Oyster Creek Generating Station
Facility License No. DPR-16
Docket No. 50-219

Subject: Response to Request for Additional Information - Proposed Alternative Repair of Control Rod Drive Housing Interface with Reactor Vessel

Response to Request for Additional Information

“Evaluation of the CRD Roll Repair at Oyster Creek”

Figure 1 Schematic Figure Illustrating the details of the Roll Repair

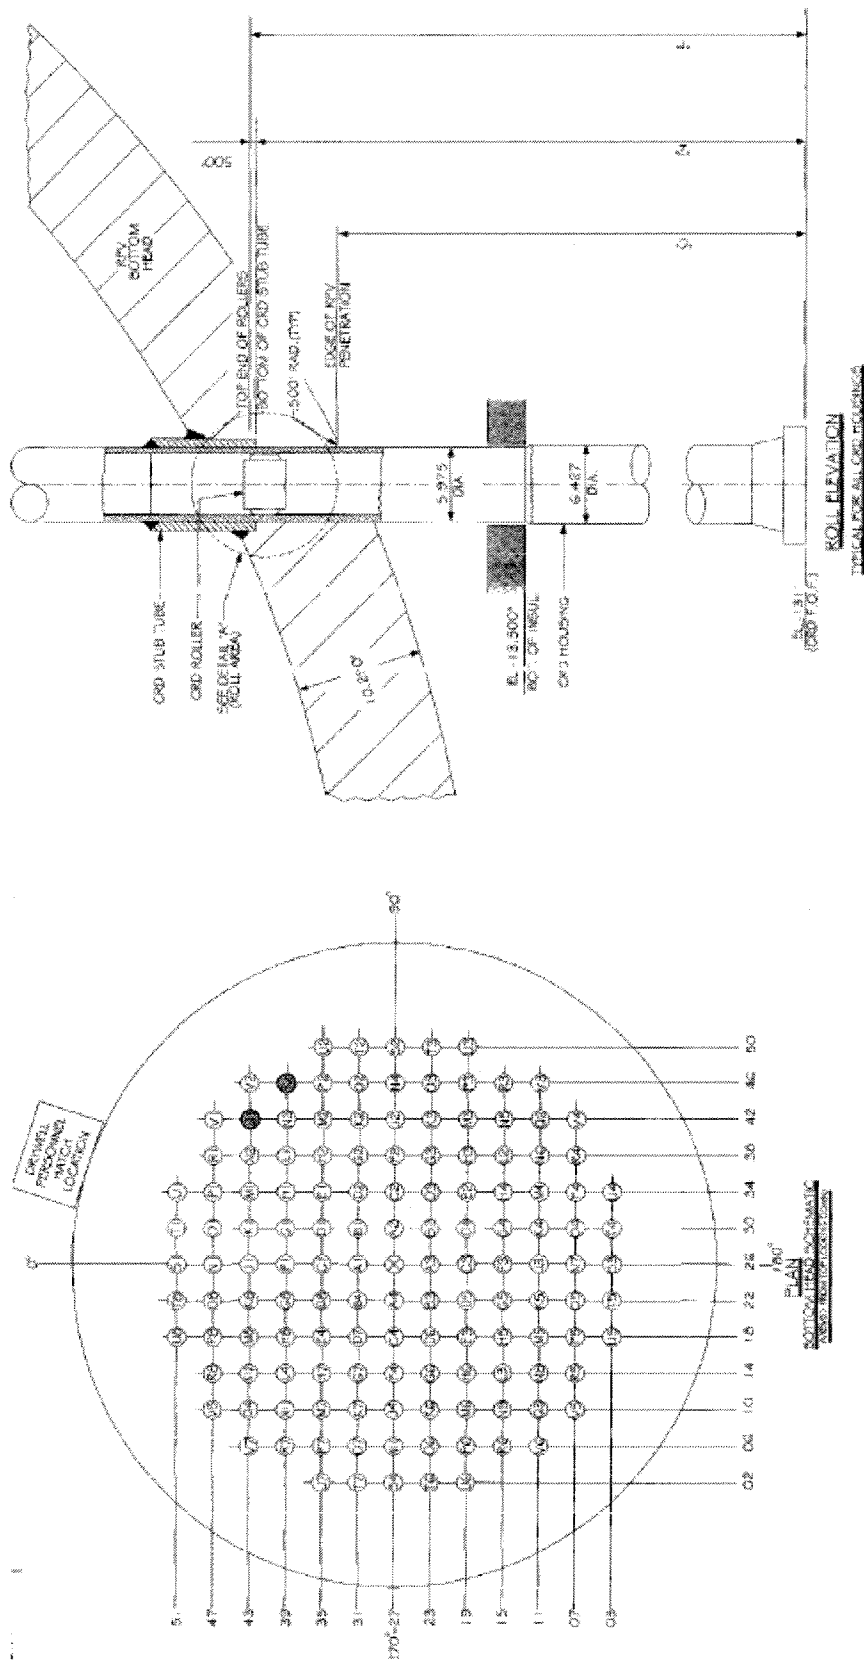
As discussed in a conference call with the NRC on July 20, 2006, a list of bounding values were identified by Oyster Creek Generating Station (OCGS) in the generic Fracture Mechanics Evaluation of a Postulated Crack in the Attachment Weld in Appendix A of the Code Case N-730 Technical Basis Report ("Technical Basis for ASME Code Case N-730 Roll-Expansion of Class 1 Control Rod Drive (CRD) Bottom Head Penetrations in BWRs, Section XI, Division 1," Report XGEN-2005-10, Revision 2, March 2006). The list and the corresponding OCGS values are as follows:

Leakage was reported in two control rod drive penetrations in the region of the stub tube weld at Oyster Creek during the Fall 2000 refueling outage. The leakage was observed in Housing No. 42-43 (Penetration Q1) and Housing No. 46-39 (Penetration R2). The configuration of the penetrations is shown in Figure 1. The stub tube is made of Type 304 stainless steel. Because of concerns about furnace sensitization during vessel post weld heat treatment, the stub tube was clad with Type 308 stainless steel weld metal. The stub tube is welded to the low alloy steel vessel bottom head with an Alloy 182 weld. Since cracking is unlikely in the clad stub tube, the most likely location of the leakage was the Alloy 182 weld. The observed leakage was minor (Table 1). The two housings were successfully repaired by roll expansion and the plant has operated without any leakage during the past six years. The roll repair has been approved by the NRC on a cycle to cycle basis.

Figure 2 Roll Band Region

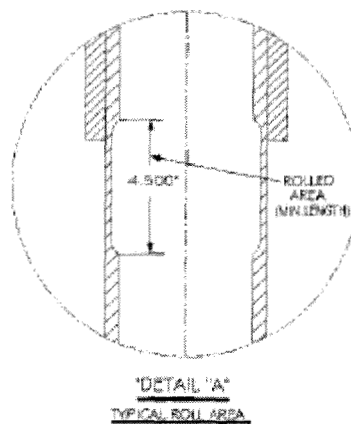
In addition to the above values, OCGS was requested to calculate the minimum roll band length (Section 4.3.1, "Roll Expansion Parameter") and the total applied stress intensity factor (Appendix A, Section A-2, "Applied Stress Intensity Factor"). Attachment 2 provides the results of these calculations. As shown in Attachment 2, the OCGS roll repair is bounded by the generic fracture mechanics evaluation.

The roll repair at Oyster Creek used a roll band length of 4.5 inches and wall thinning of 6%. Figure 2 shows the schematic of the roll repair detail.

band, the roll band length with the full 6% wall thinning is 3 inches. Table 2 shows the CRD scram loads (from Reference 3) for the different plant conditions. The bounding scram load of 13 kips per CRD is used for the determination of the required roll band length.

Substituting F (including the structural factor of 2) = 26 kips, p=0.06, T = 0.5 in and S_y = 30 ksi (Code minimum value at room temperature), the required roll band length is determined to be 1.47 in. The actual roll band length (3 inches after excluding the roll radius region) is in excess of the minimum requirement.
